KWM-380 TRANSCEIVER (622-5093-101)  
HF-380 TRANSCEIVER (622-3580-101)  
RECEIVER-EXCITER CIRCUIT CARD A3 (638-6908-001)

SERVICE BULLETIN NO 1

PRODUCT IMPROVEMENT

The parts listed below are required to modify one KWM-380 or one HF-380.

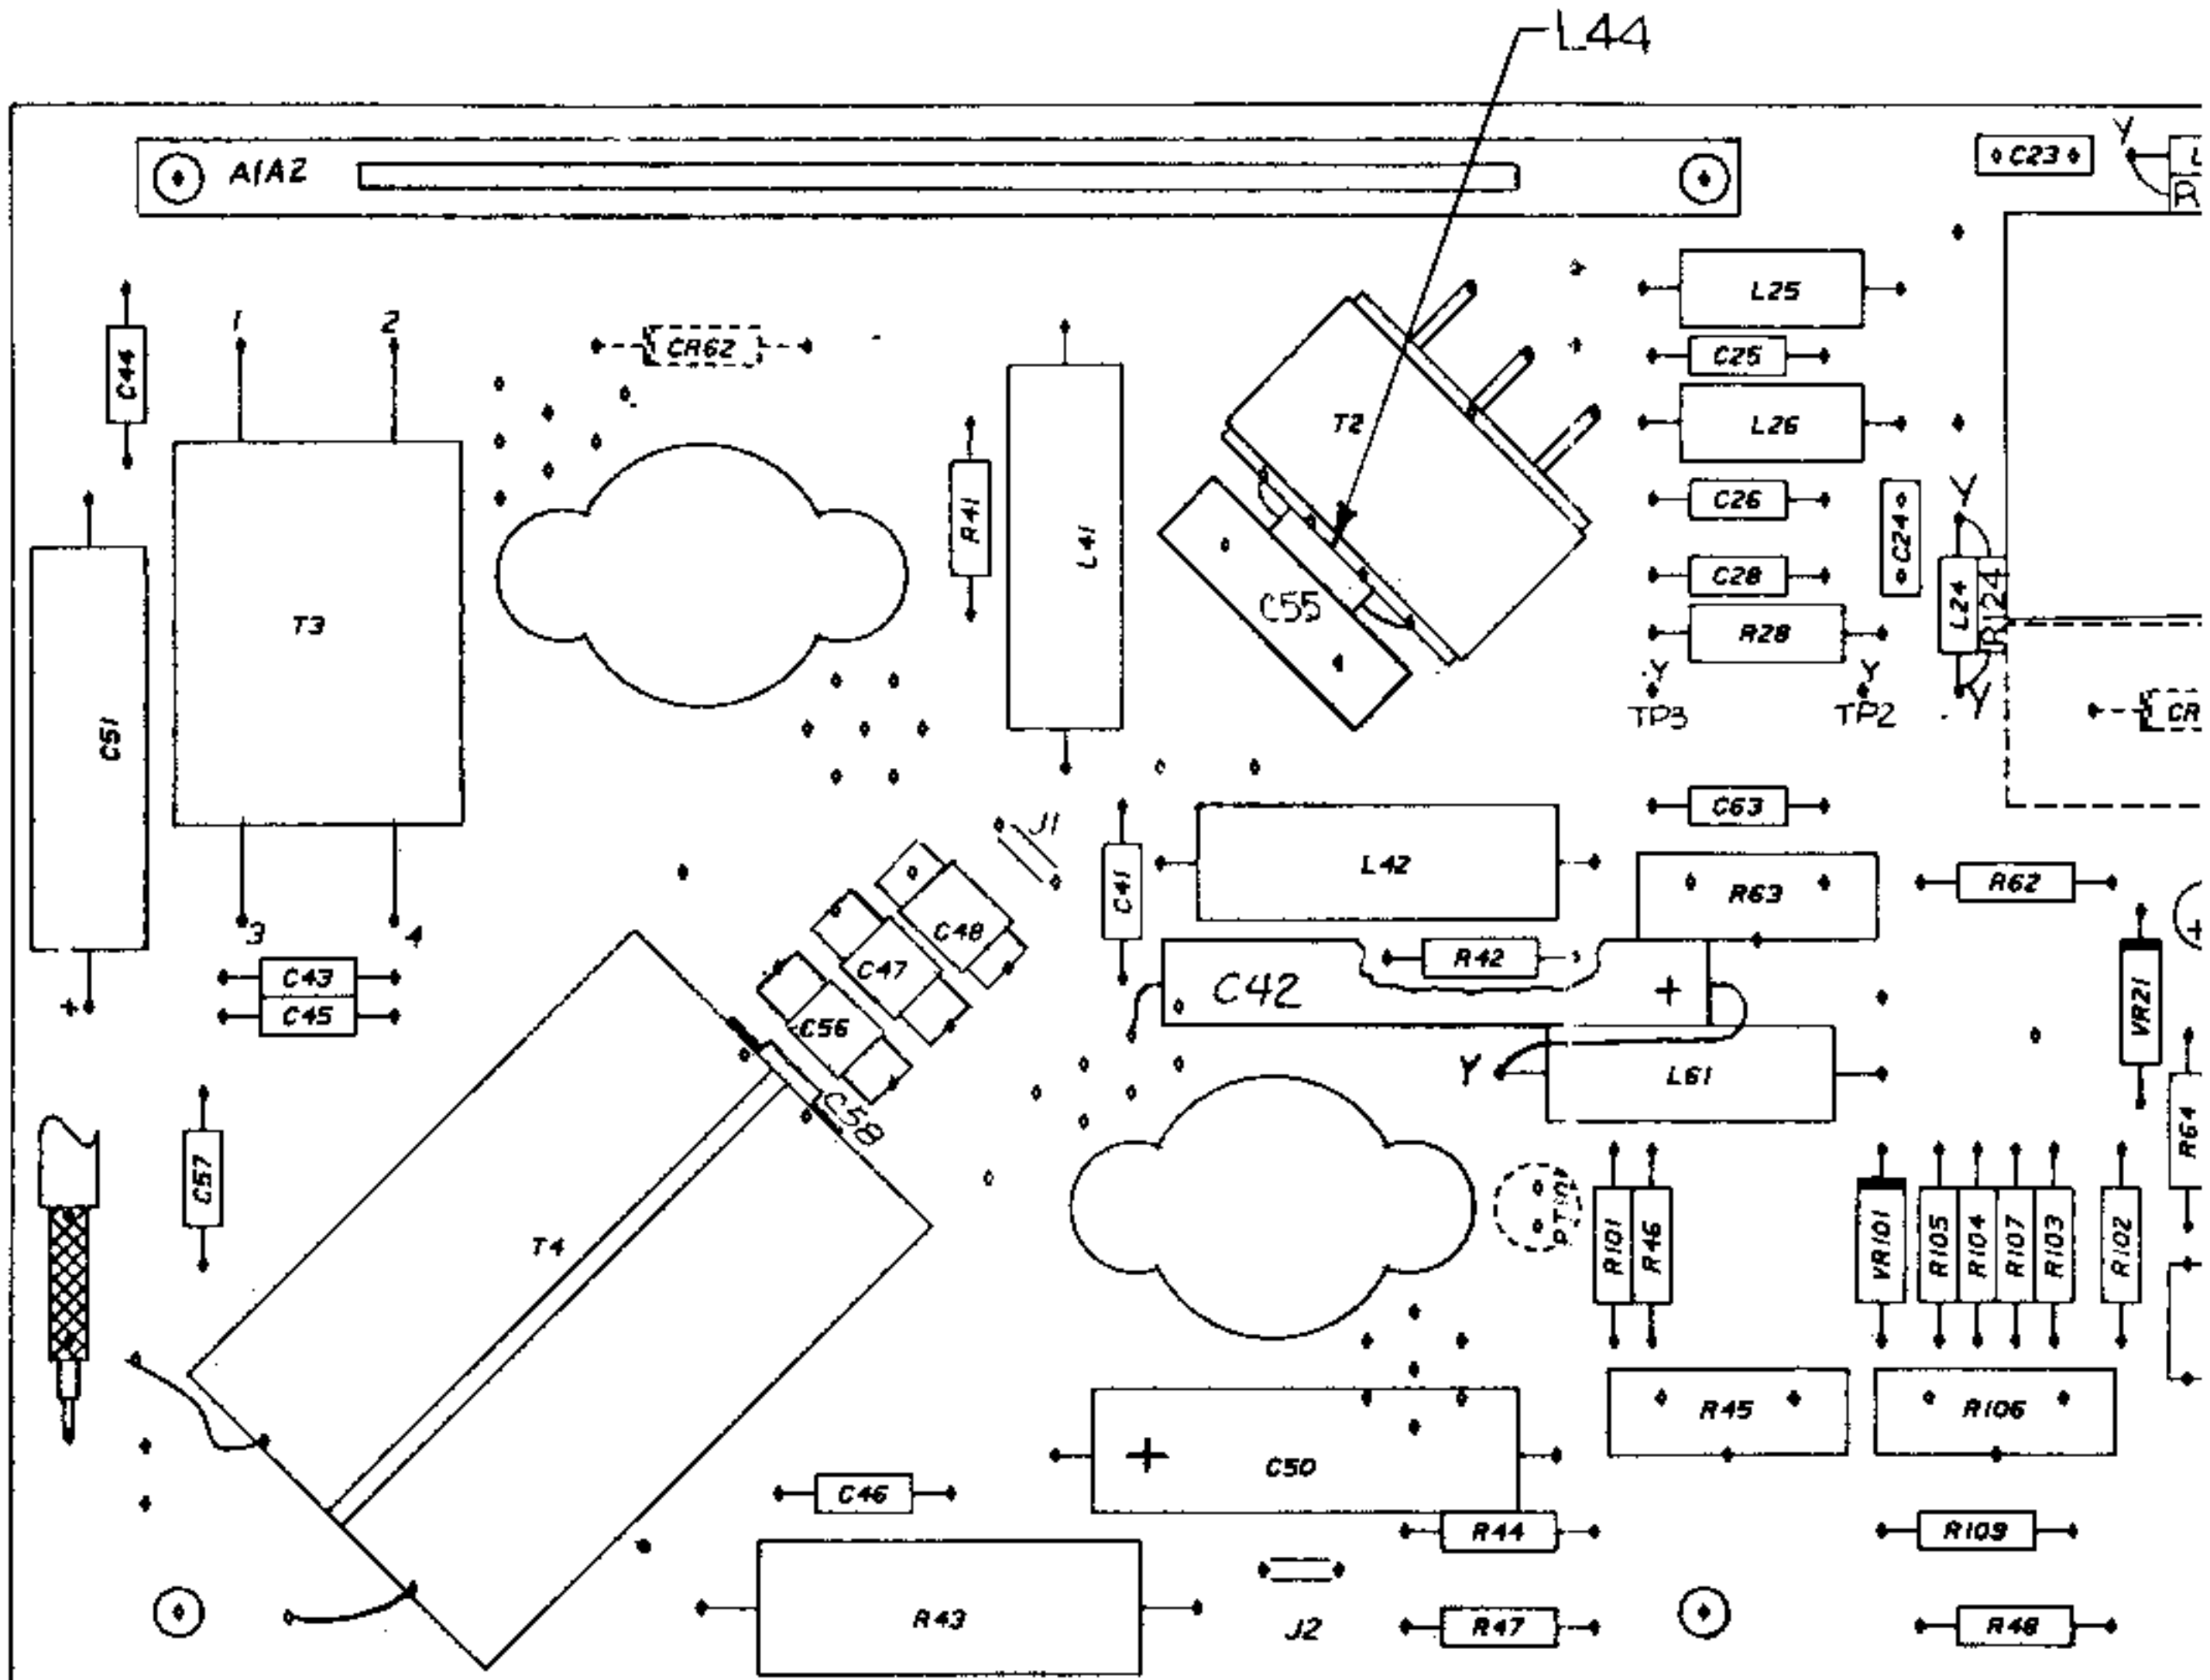
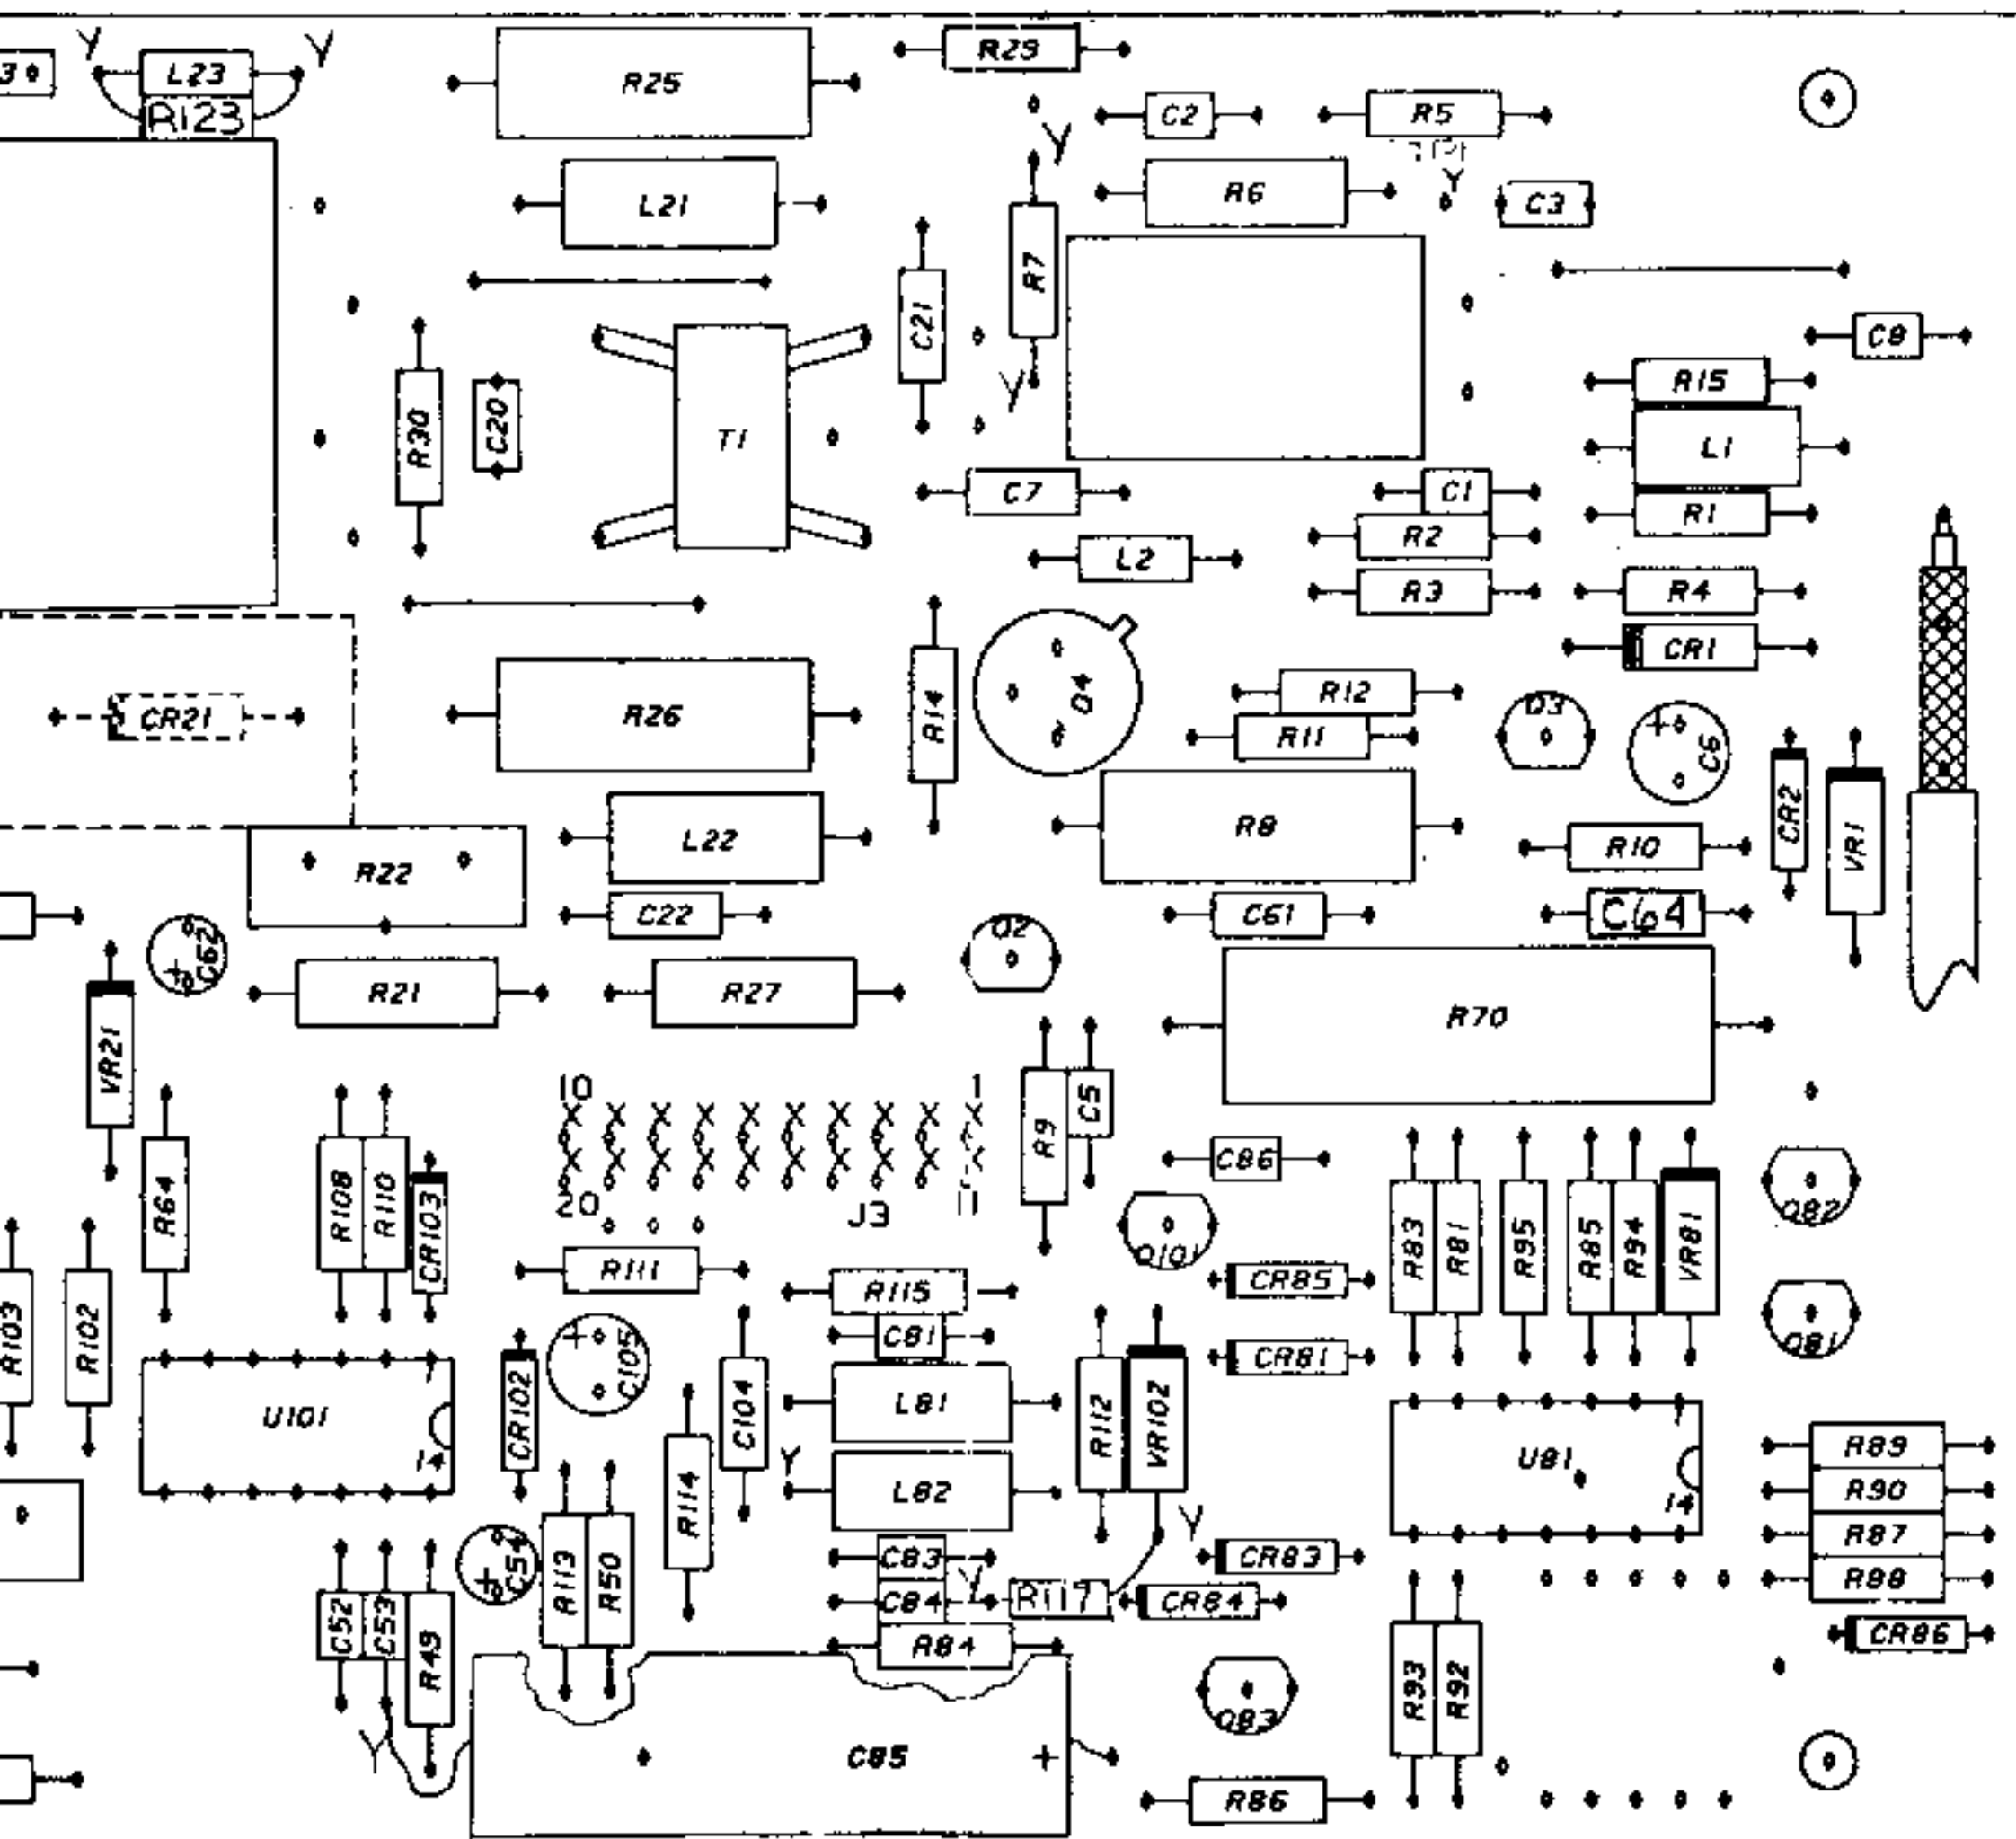
NOTE: Do not remove circuit card A1A1 from power amplifier/heat sink assembly A1. Refer to figure 1 while performing steps E through T. Refer to figure 2 for a schematic diagram of the latest configuration.

- E. Remove 1500-pF capacitor C55 by cutting the leads close to the body of the component. Leave the capacitor leads soldered into the circuit card.
- F. Install a 1000-pF capacitor (912-3315-000), connecting the leads to the leads of the capacitor removed in step E.
- G. Install a 2.7- $\mu$ H coil L44 (240-2715-180) as shown in figure 1, detail A.
- H. Remove 0.27- $\mu$ H inductors L23 and L24 by cutting the leads close to the component body. Leave the inductor leads soldered into the circuit card.
- I. Install two 3.3- $\mu$ H inductors (240-2029-000), connecting the leads to the leads of the inductors removed in step H.
- J. Install 100- $\Omega$  resistor R123 (745-1310-000) in parallel with L23. Wrap the resistor leads around the coil leads and solder.

- Q. Remove and discard 68- $\Omega$  resistor R116.
  - R. Install electronic components assembly A1A2 (647-2781-001) onto the circuit card as shown in figure 1 using the existing hardware.

- S. Wind two turns of brown wire (422-0795-000) in transformer T3 as shown in figure 1, detail B. Connect to A1A2 assembly as shown in figure 1, detail D. If the transformer core has potting in the holes, carefully clear a way for the brown wire, using a stiff wire such as a straightened paper clip.

- T. Wind two turns of red wire (442-0796-000) in transformer T2 as shown in figure 1, detail D. If necessary, clear the core of potting as in step S.

- NOTE: The added wires in steps S and T must be oriented as shown in figure 1, details B and C, to prevent oscillation.
- U. Reassemble the transceiver in the reverse order of disassembly.

NOTE: LEADS FROM T2 AND T3 MUST BE CAREFULLY POSITIONED AS SHOWN TO PREVENT DESTRUCTIVE OSCILLATION.
